Regular Virtual Meeting
Canton Planning and Zoning Commission
Wednesday, October 21, 2020 at 7:00 pm
Call-In Number: +1 (408) 650-3123

1. File 475; ApIn 2000; 9 and 15 Albany Turnpike; Assessor Map 32 and 36; Parcel 1010009 and 1010015; Zone: B; Special Permits: Section 4.1.C.1.a., retail/service businesses and personal service businesses greater than 2,500 square feet; Section 4.1.C.2.b., outdoor dining when accessory to restaurant classes I, II, or III; Section 4.1.C.3.a., drive-thru uses; Section 4.1.C.10.a., new car dealership, as defined by CGS Section 14-51(1); Section 4.1.C.10.e., gasoline filling stations; Section 7.3.F.8.a., sign approval by special permit; Section 7.5.D.3., earthwork and grading over 2,000 cubic yards; Section 7.7.C.3., retaining wall by special permit; Section 7.10.B.2, outdoor storage and display; and Site Plan Application: Section 4.1.B.3., restaurant classes I & II; Section 9.1.A., request to construct a 8,384 sq. ft. gas station/convenience store with restaurants and drive-thru, and 23,500 sq. ft. electronic vehicle showroom with 117 associated parking spaces; 9-15 Albany Turnpike, LLC, applicant/owner

**RE:** Site Plan & Special Permit Application

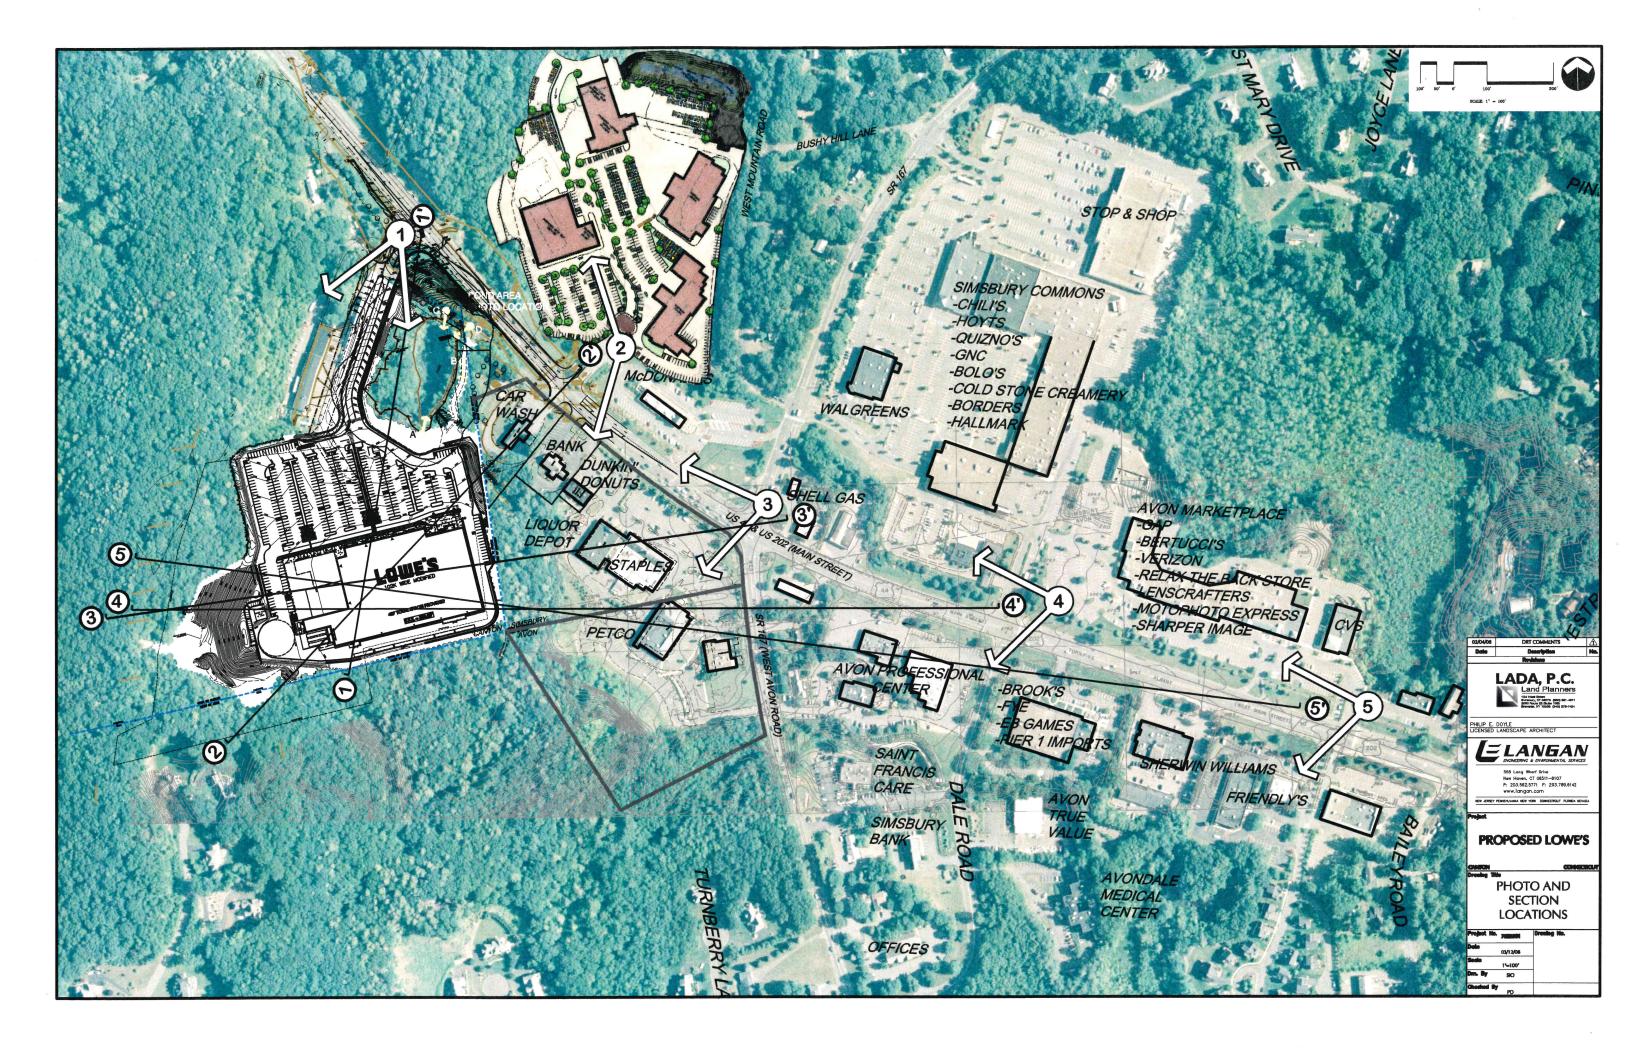
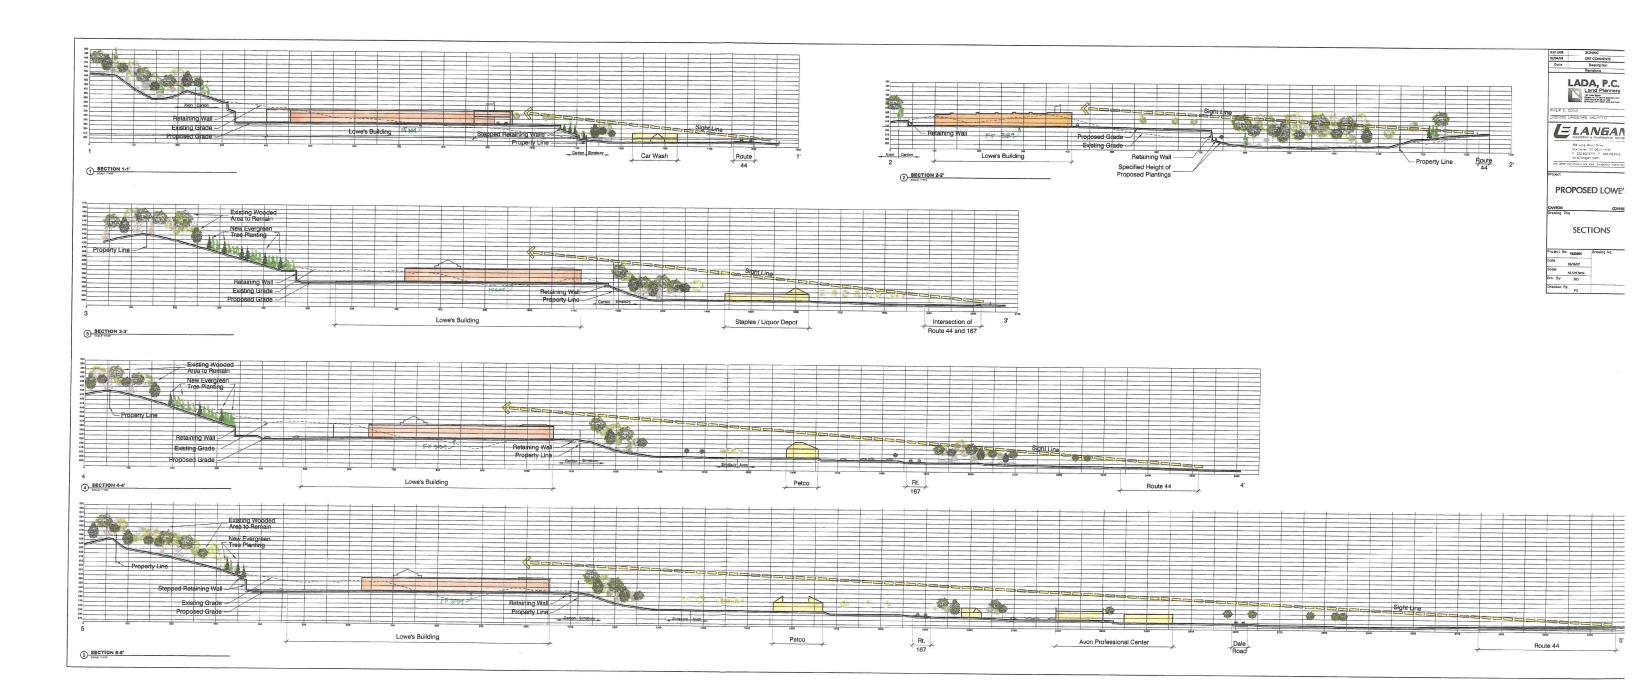
Along the lines of our conversation yesterday, it is difficult to reconcile the building design and associated aesthetics and character with the special permit criteria referenced in the staff report.

As mentioned the information provided does not clearly present the relationship of the two buildings together that are proposed to share this site, or to the context of the area. As a gateway into Canton, I think it is important that the Commission and public have an understanding of what the final site would look like, inclusive of site work, representation of final grades and the buildings placed upon them, presented at actual vantage points. While the renderings are impressive, they are not a realistic representation of what the community will see if the projects is approved and constructed as proposed.

Therefore I have added into the packet examples of what has been provided in the past in a similar application, relatively in the same location, to show what the anticipated changes to the viewshed would be. The examples are too big to attach, but they are included on Pages 130 – 137 of the meeting packet. I would like to see something similar provided for this project in addition to something that shows the two buildings together on the site in the same image, at the appropriate grades and realistic vantage point.

Figure 4 - Retaining wall next to Kohl's at The Shop's

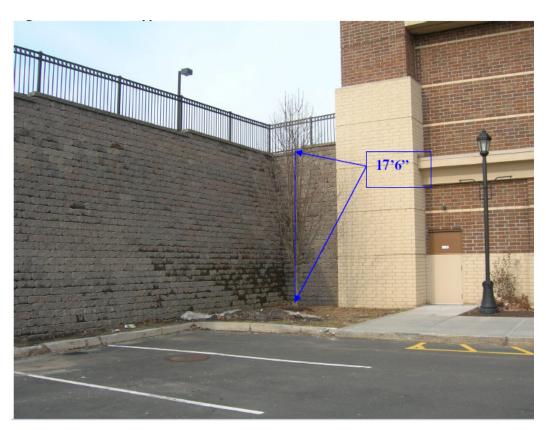
#### 25. Page A-20, Item #25.33, Section 7.7 Fences and Walls –

- a. A special permit is required for walls of this nature per this section.
- b. Standard maximum height of a retaining wall is 8' per Section 7.7.C.2. The application proposes a wall at a maximum height of 52' on top of a 5' slope. For comparison, below are examples of the two tallest retaining walls within the Town of Canton. The proposed wall maximum height is approximately three hundred percent greater.
- c. Top of Wall and Bottom of Wall elevation references should be provide along the proposed wall layout.
- d. A fence will be provided at the top of the retaining wall, the height of which is not identified.
- e. The Special Permit Criteria of 9.2.E must be evaluated in relation to the proposed walls
